STAFF RECOMMENDATION
1712 Blair Boulevard
March 17, 2021

Application: New Construction—Outbuilding
District: Belmont-Hillsboro Neighborhood Conservation Zoning Overlay
Council District: 18
Base Zoning: RM20
Map and Parcel Number: 10416004300
Applicant: Will Jenner
Project Lead: Melissa Sajid, melissa.sajid@nashville.gov

Description of Project: Application is to construct an outbuilding that is less than twenty feet (20') from the addition approved in December 2020.

6 GARAGE RIGHT ELEVATION
1/4" = 1'-0"

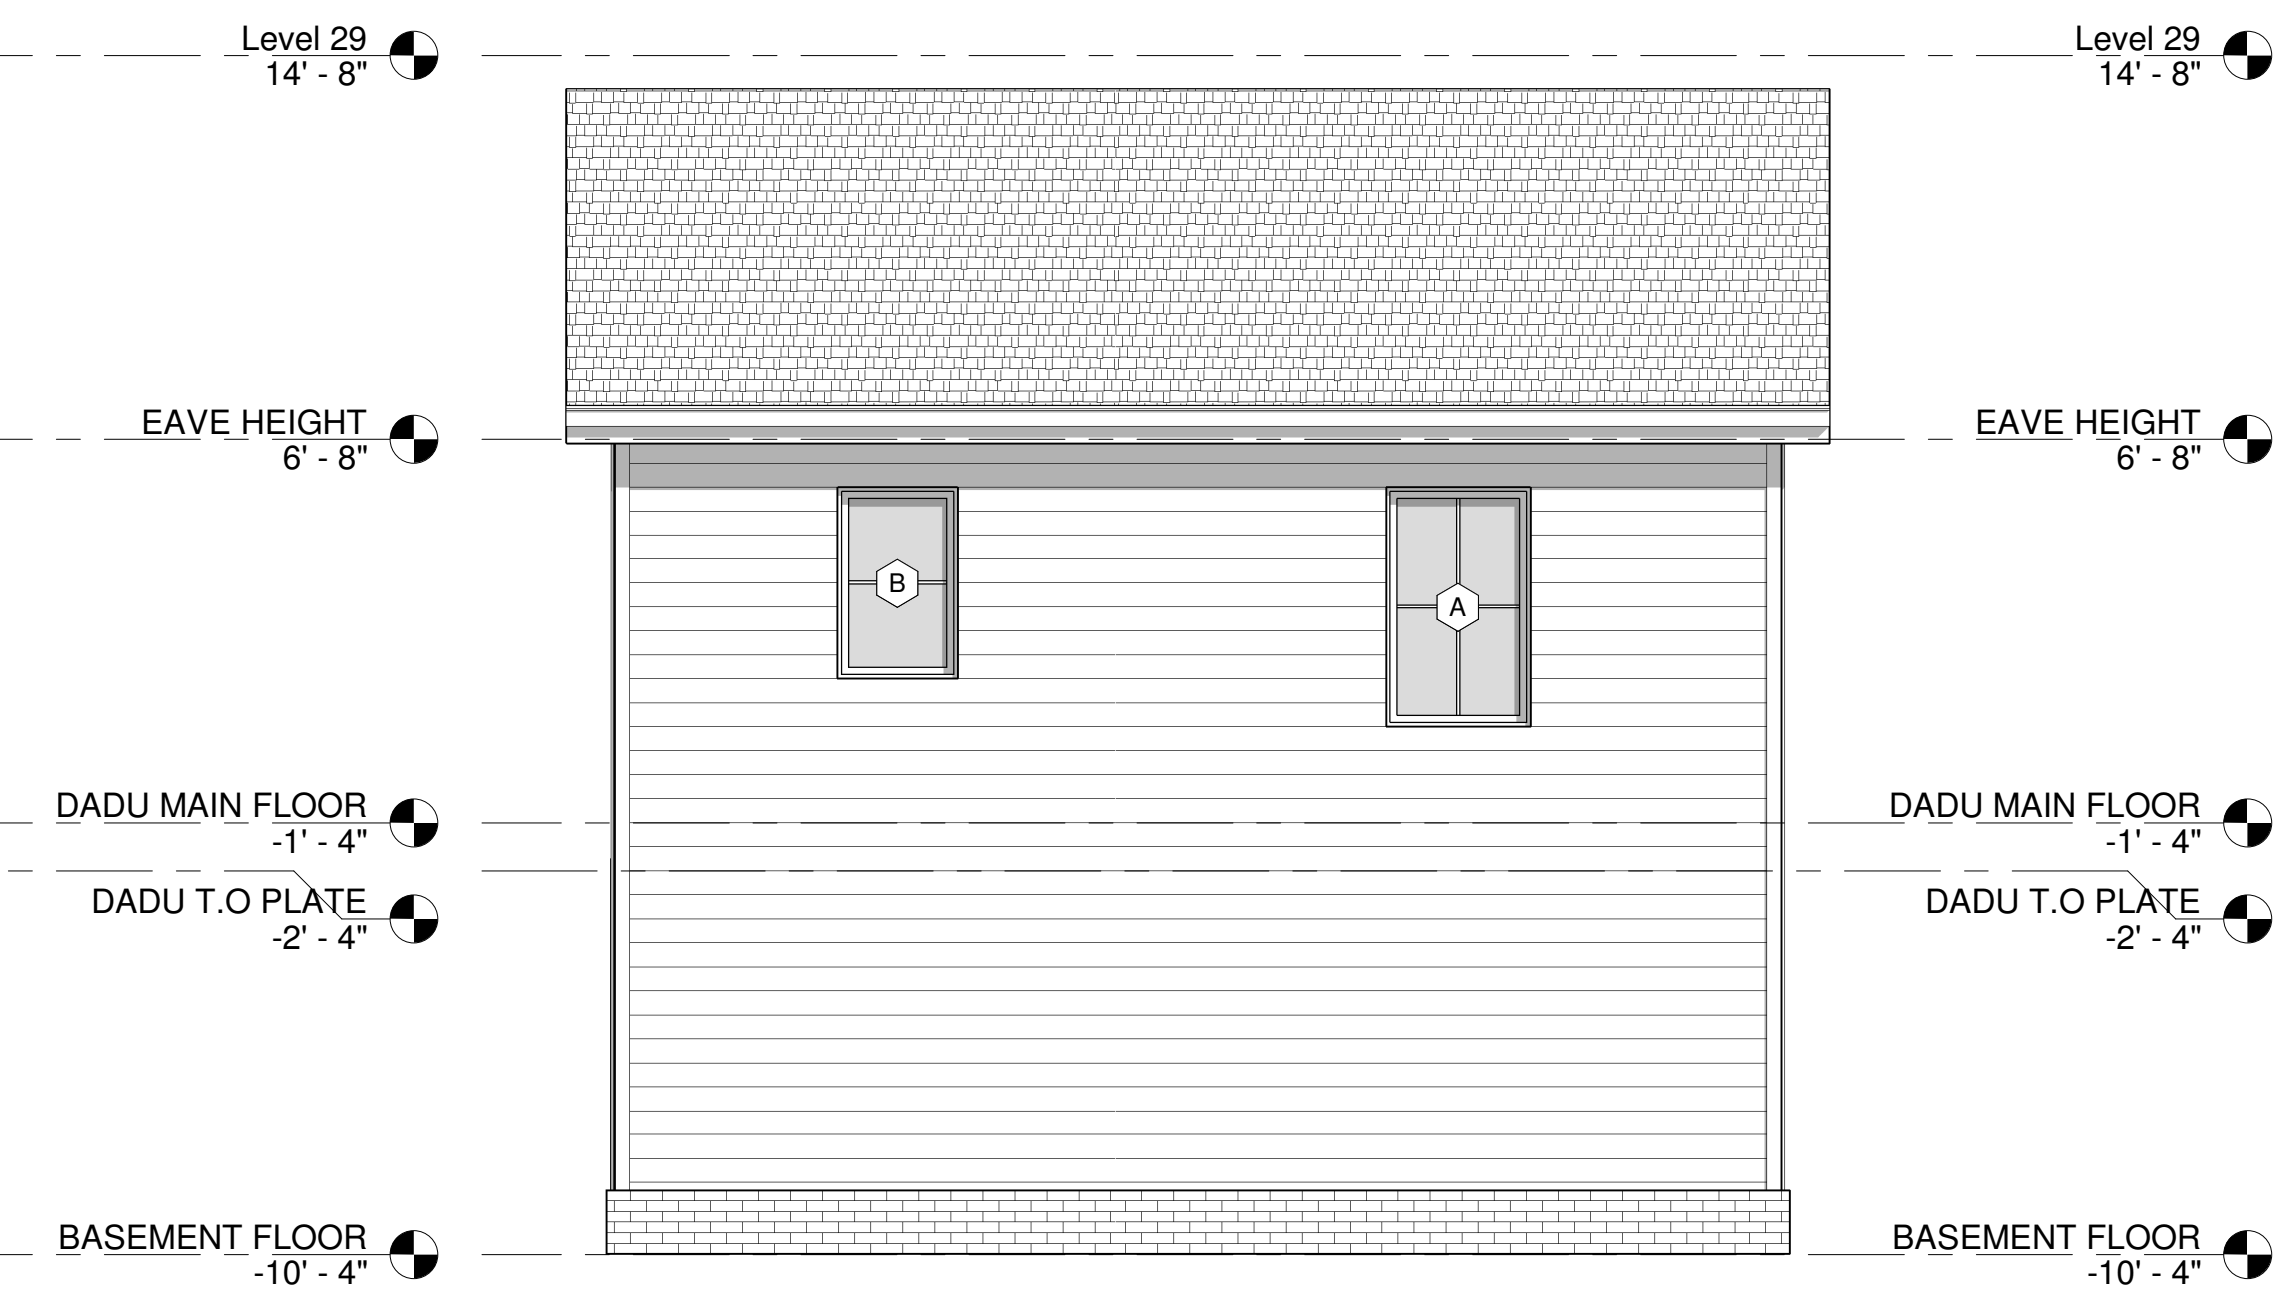
Potential maximums under Ordinance	Existing House	Proposed Outbuilding
Ridge Height	25' unless existing building is less	~ 36'	~24'4"
Eave Height	17'	~ 22'-6"	17'

Proposed Element	Proposed Outbuilding	Typical of district?
Primary form	Gable	Yes
Primary roof slope	~ 6/12	Yes

Proposed Outbuilding	Color/Texture	Needs final approval?
Foundation	Not indicated	Unknown	Yes
Primary cladding	Not indicated	Unknown	Yes
Trim	Not indicated	Unknown	Yes
Roofing	Not indicated	Unknown	Yes
Windows	Not indicated	Unknown	Yes
Doors	Not indicated	Unknown	Yes
Garage door	Not indicated	Unknown	Yes

1. Staff approve the final details, dimensions and materials of all materials prior to purchase and installation; and
2. Siding shall have a smooth finish and a maximum reveal of five inches (5").
